NEW GAS STATION, C-STORE, DRIVE-THRU
A.L. PRIME #TBD
23 CENTRAL STREET
BYFIELD, MASS

THIS SET ISSUED FOR SPR & SP 10/7/20 2nd HRG, W/ REVISIONS PER CMTS

PROJECT
COVER SHEET

| UTILITIES | | | | | | | |

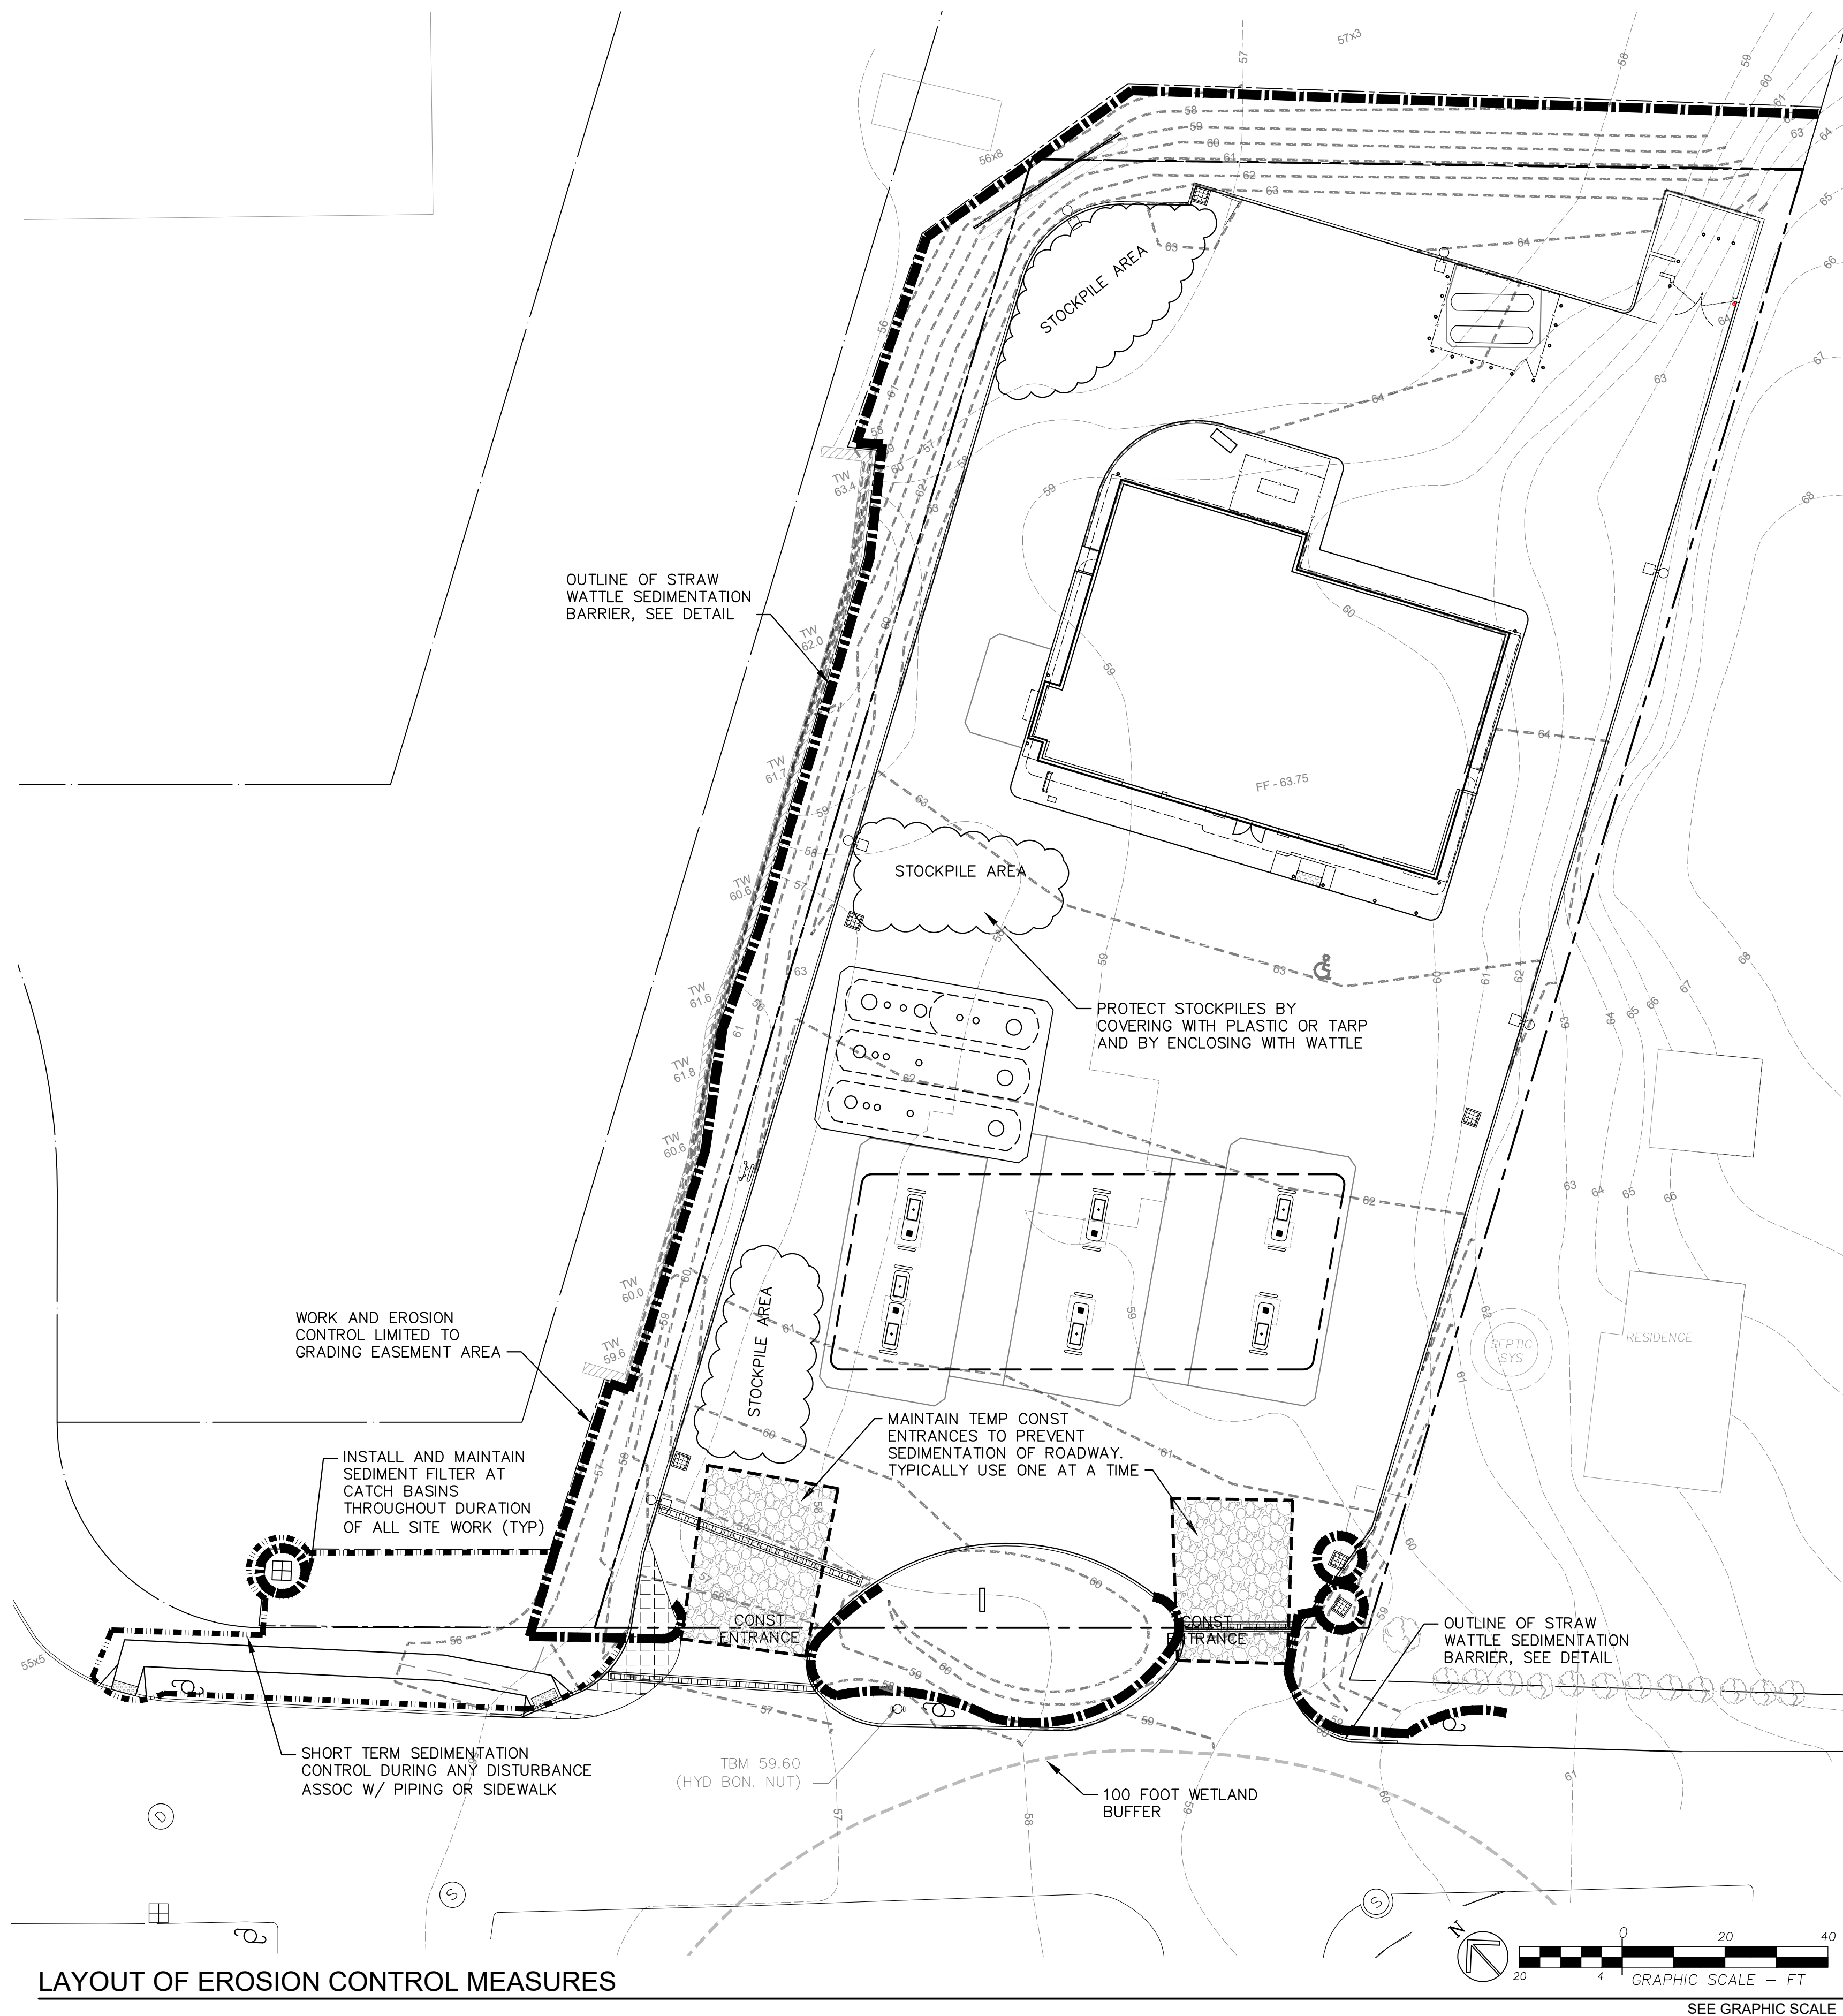
| 23 SEP 2020 1 AG CHANGED ELECT TO UG. MOVED PROPANE. REV PER CMTS | | DATE | | 29 APR 2020 0 AG ORIGINAL DRAWING DATE | | DATE | |

| EROSION CONTROL | | | | | |

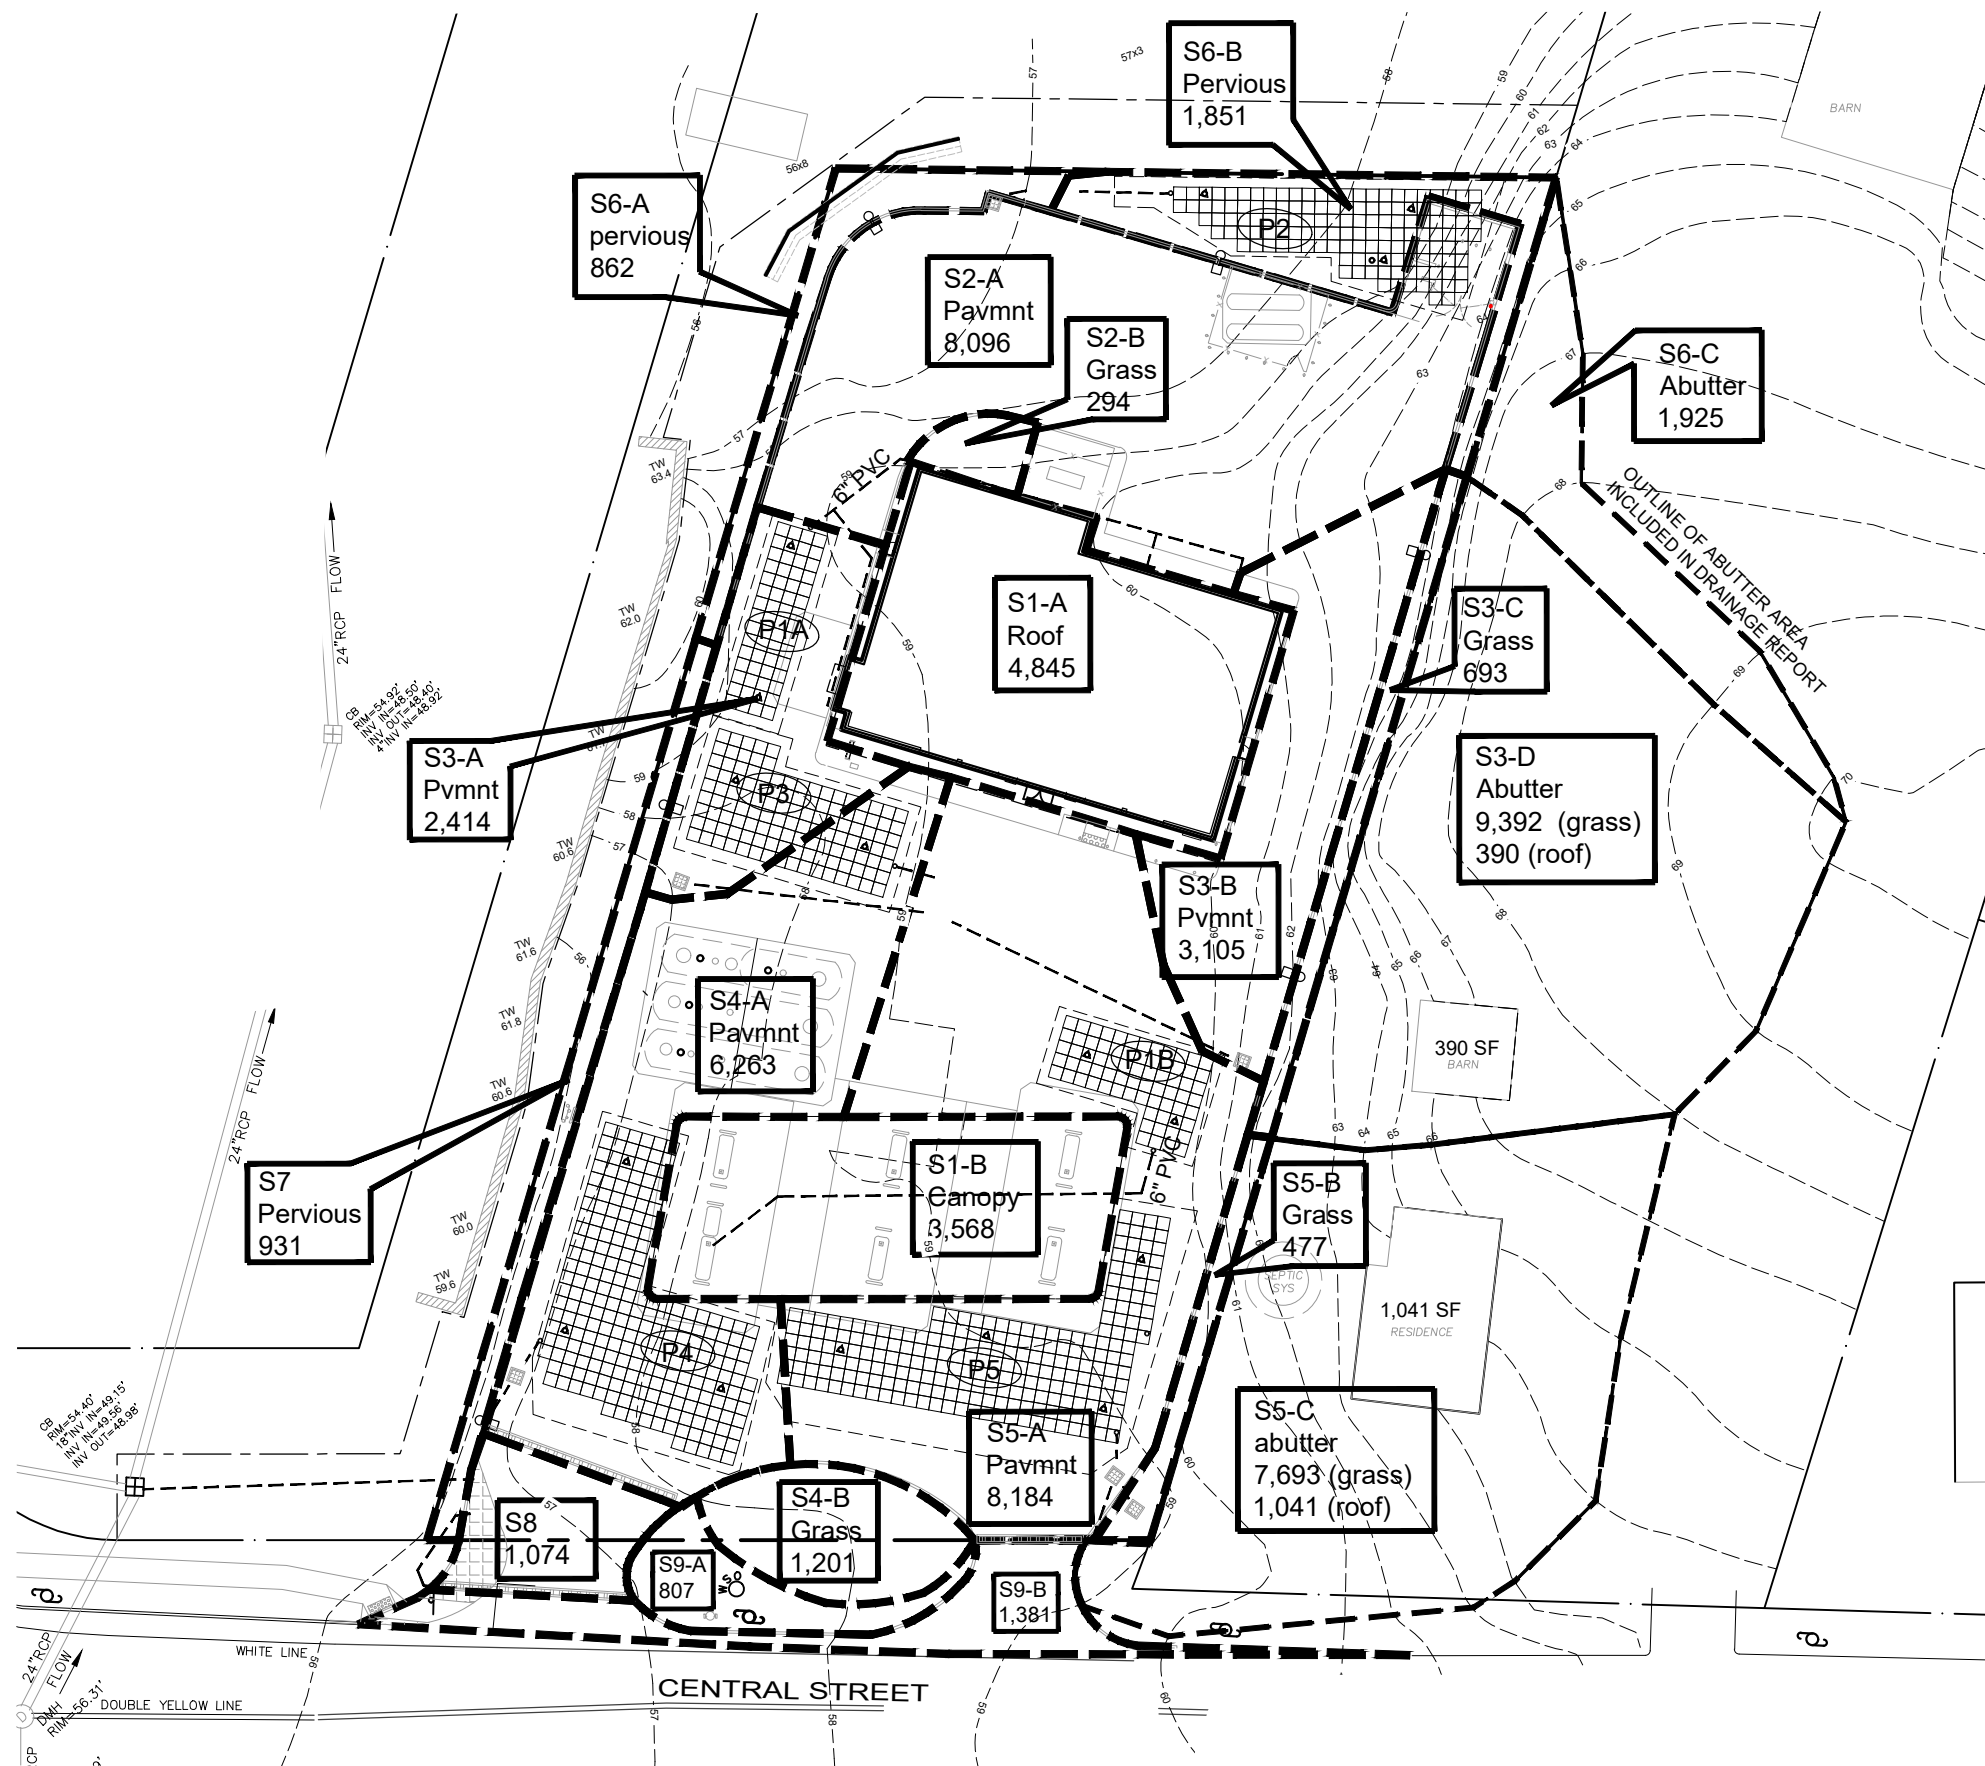
| 09-23-2020 04-29-2020 | 1 0 | AG JAG | ADDED EASEMENT LINE, ADJ SEDIMENTATION LINE ORIGINAL DRAWING DATE | REV BY DESCRIPTION | DATE |

PRE AND POST DEVELOPMENT STORMWATER RUNOFF AREAS AND FLOW DIRECTIONS

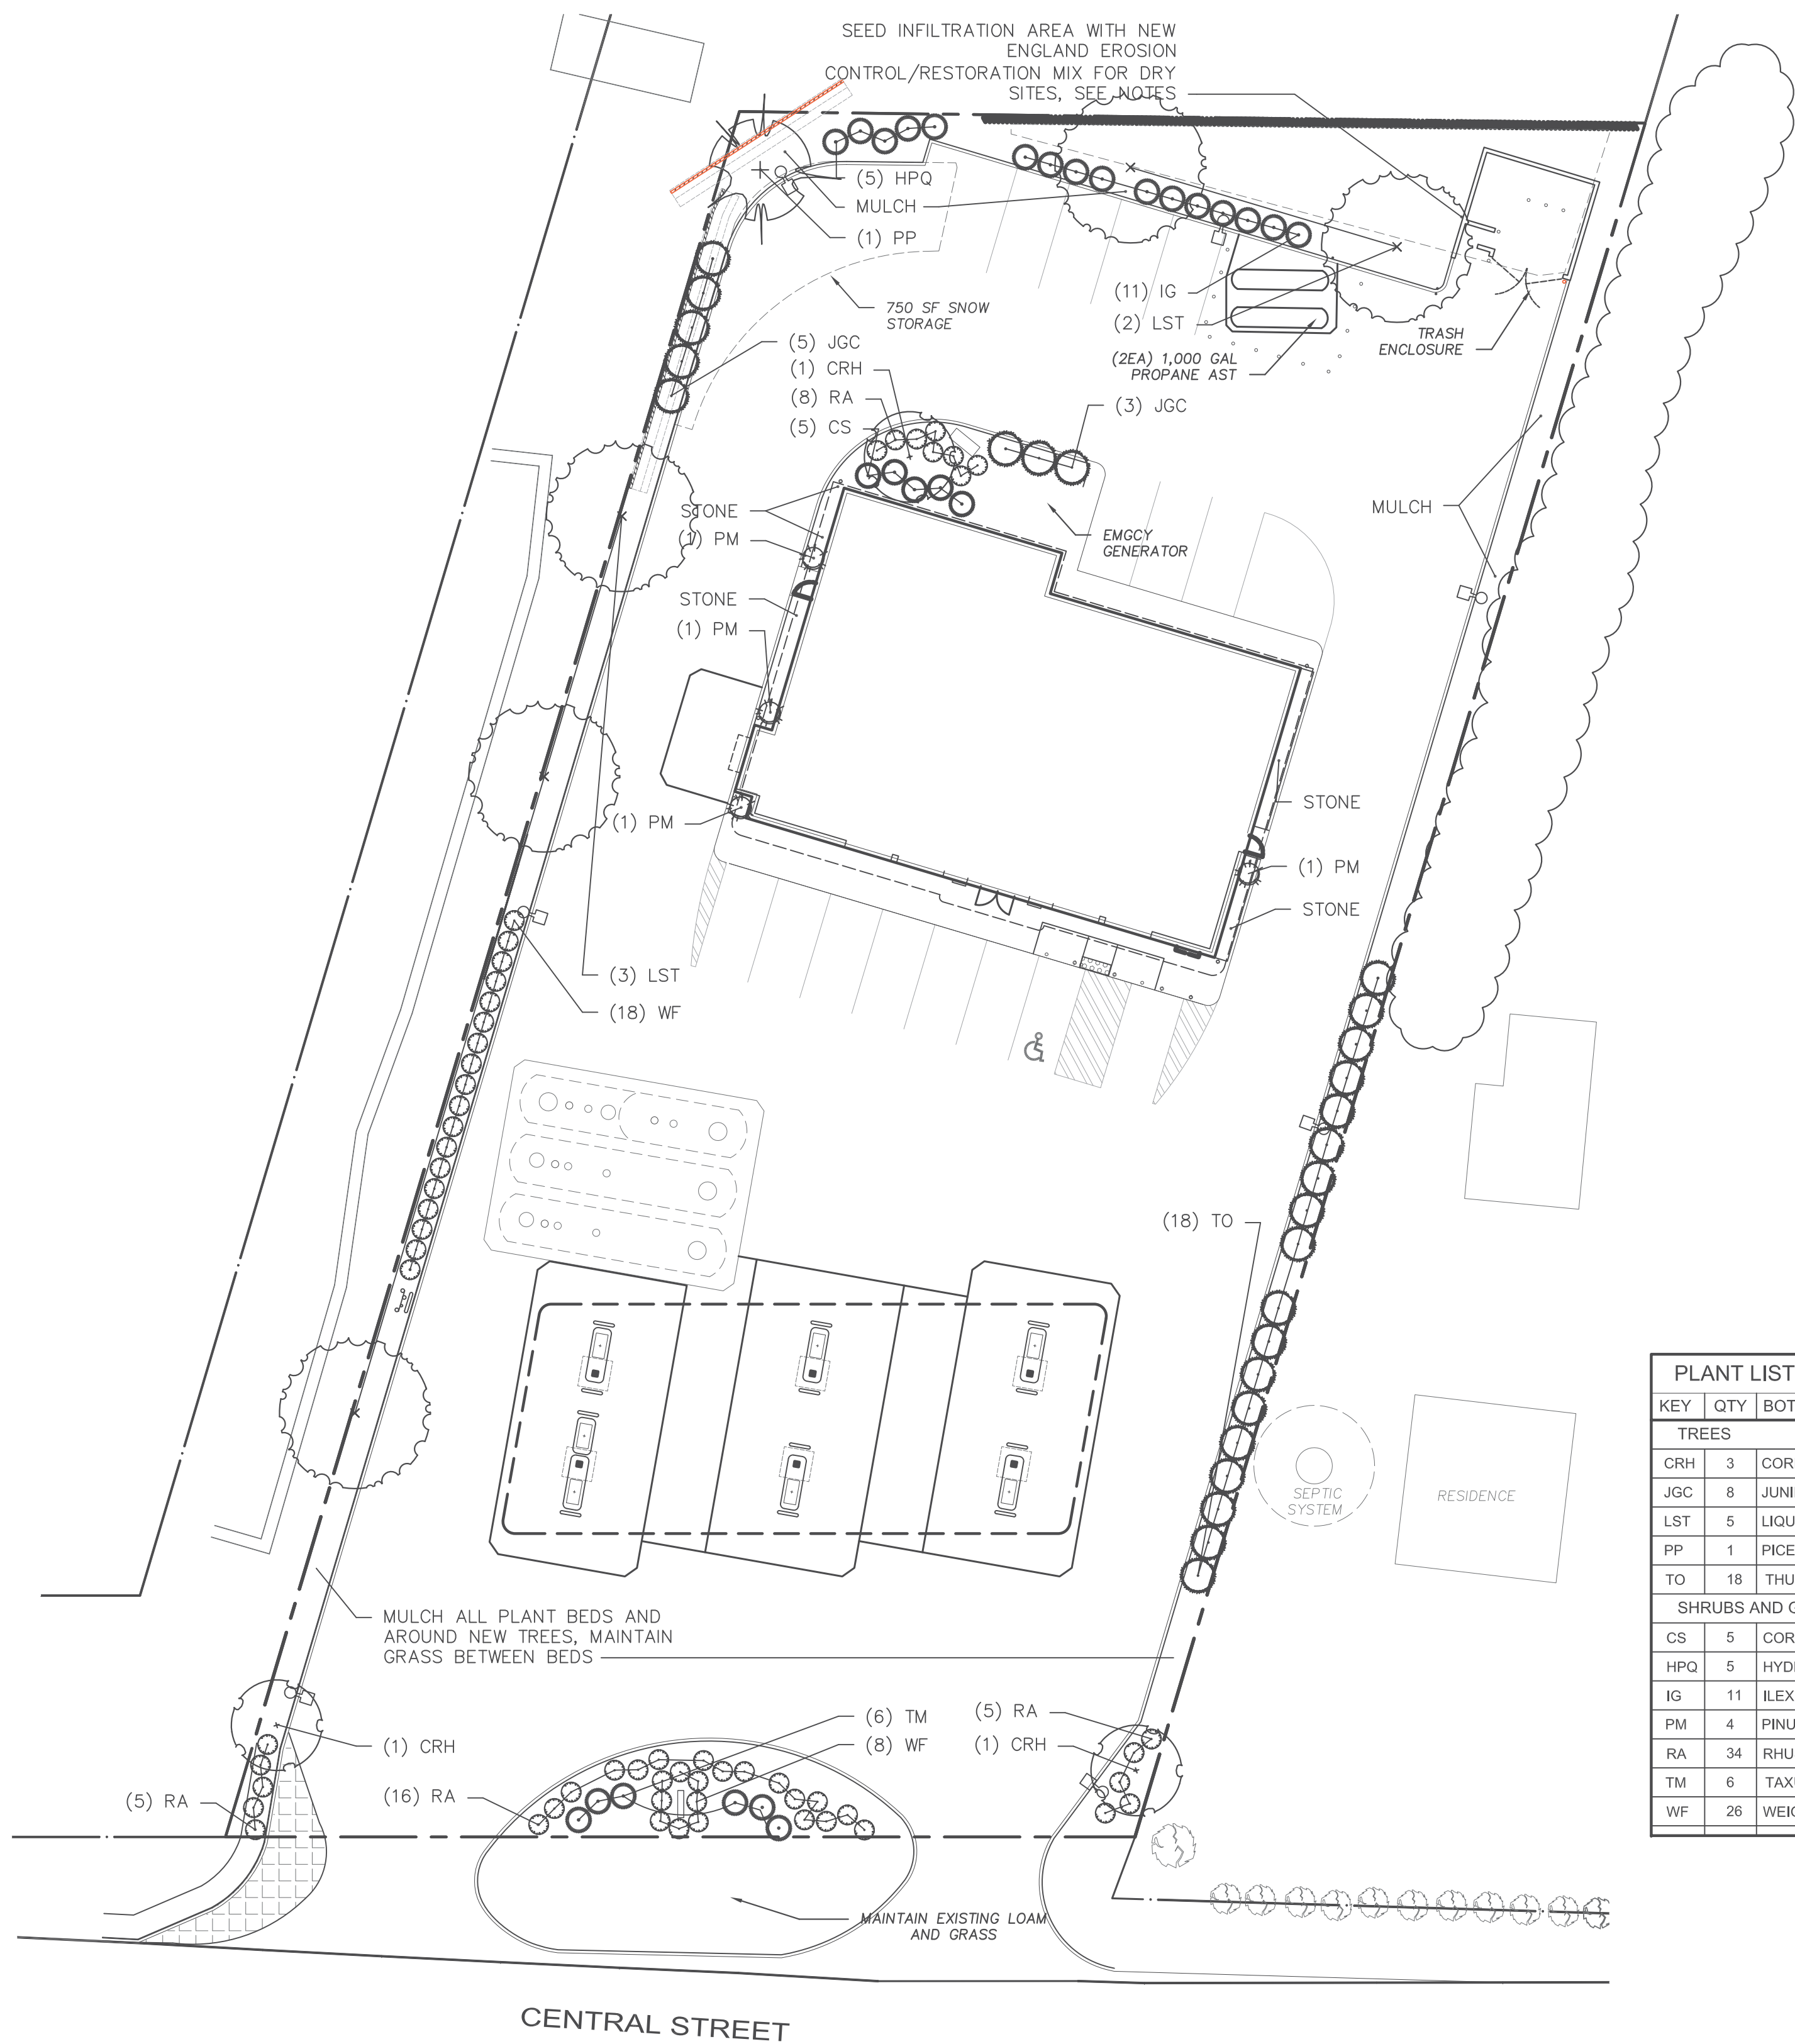
23 SEP 20201 AG ADDED ABUTTER AREAS THAT AFFECT SITE RUNOFF
